Technical Service BULLETIN

Title:
RATTLE NOISE FROM
EXTERIOR MIRROR

'06 - '07 RAV4

NV012-07

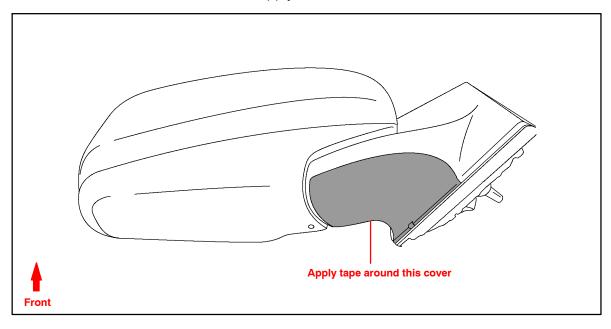
- Confirm that the rattle noise is coming from exterior mirrors.
 Apply tape around outer mirror cover (see illustration below)
 - If noise goes away, proceed to step 2.
 - If rattle noise is NOT eliminated, **STOP**. The source of noise is from a different location. This TSB does **NOT** apply.

- 2. Replace the outer mirror covers with **NEW** service parts.
- 3. Test drive and confirm rattle noise is gone.
